BULLETIN NO. 6

TO : **Conventional Builders**
FROM : **Nimesh Patel**
DATE : **February 28, 2019**
PROJECT : **DeIDOT Phase II Renovations**

PROJECT: STATE OF DELAWARE
 DELAWARE DEPARTMENT OF TRANSPORTATION
 OMB/DFM PROJECT # MC5511000018
PHASE II RENOVATION AND OCR COMPLIANCE PROJECT
 AT
 KENT COUNTY ADMINISTRATION BUILDING
 800 BAY ROAD DOVER, DELAWARE 19901

PLAN @ STORAGE - 109

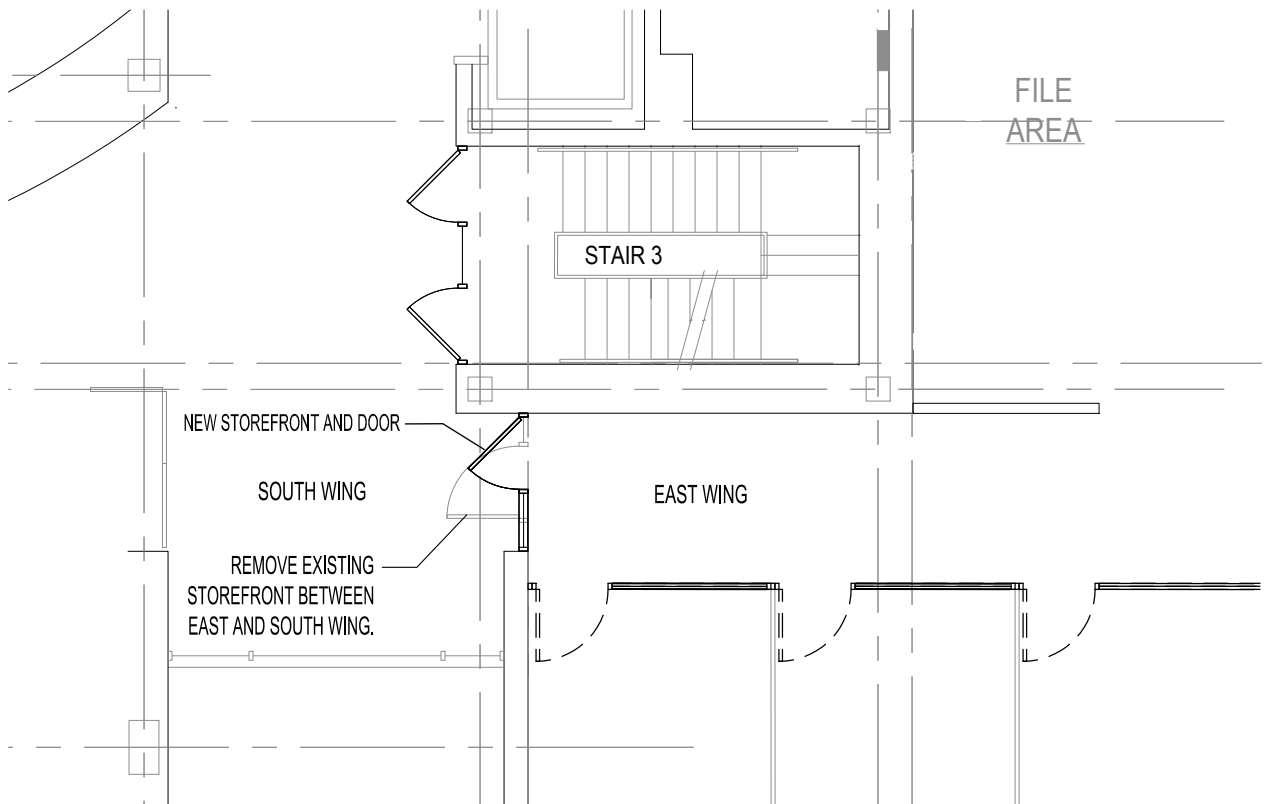
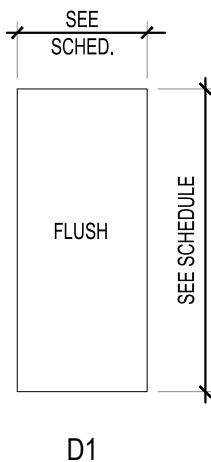
1. Refer to attached SK-A.7
 - a. Door #109 – In addition to hardware indicated on Submittal #DOT-081113-18 dated 1/24/19, provide an electric strike and power supply. Confirm wiring path in field to electric strike. Configure door hardware to work with card reader access. Card reader will be furnished and installed by others.

2. Refer to attached SK-A.7
 - a. Door #109A – Provide new insulated hollow metal door and hardware.

DOOR #109 - IN ADDITION TO HARDWARE INDICATED ON SUBMITTAL #DOT-081113-18 PROVIDE THE FOLLOWING:

- ELECTRIC STRIKE AND POWER SUPPLY - CONFIRM WIRING PATH IN FIELD TO ELECTRIC STRIKE. CONFIGURE DOOR HARDWARE TO WORK WITH CARD READER ACCESS. CARD READER WILL BE FURNISHED AND INSTALLED BY OTHERS.

DOOR #109A - INSULATED HOLLOW METAL DOOR

- 1 CONTINUOUS HINGE
- 1 THRESHOLD
- 1 SURFACE CLOSER
- 1 KICK PLATE - TO MATCH INTERIOR OF DOOR #109
- 1 LOCKSET
- 1 WEATHERSTRIPPING
- 1 SWEEP
- 1 THRESHOLD
- 1 RAIN DRIP
- 1 ELECTRIC STRIKE
- 1 POWER SUPPLY

CONFIGURE DOOR HARDWARE TO WORK WITH CARD READER ACCESS. CARD READER WILL BE FURNISHED AND INSTALLED BY OTHERS.

PLAN @ SECOND FLOOR

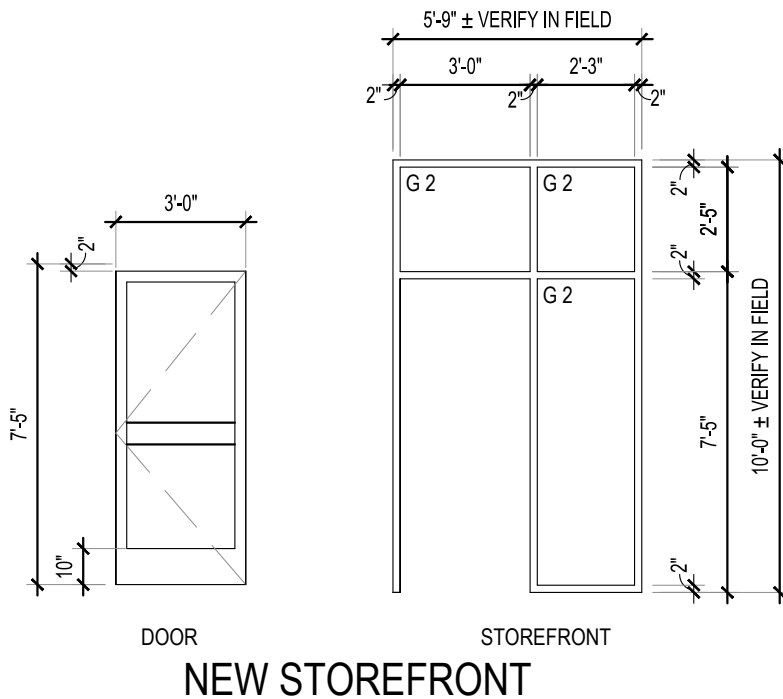
3. Refer to attached SK-A.8
 - a. Remove existing storefront between East and South wing as shown on SK-A.8
 - b. Provide new door and storefront to match existing storefront located in same location on first floor. Provide hardware and security access requirement to match existing door located on first floor.

PROVIDE NEW STOREFRONT AND DOOR TO MATCH DOOR AND FRAME IN SAME LOCATION ON FIRST FLOOR.

MATCH HARDWARE AND SECURITY ACCESS REQUIREMENTS TO EXISTING FIRST FLOOR DOOR IN SAME LOCATION.
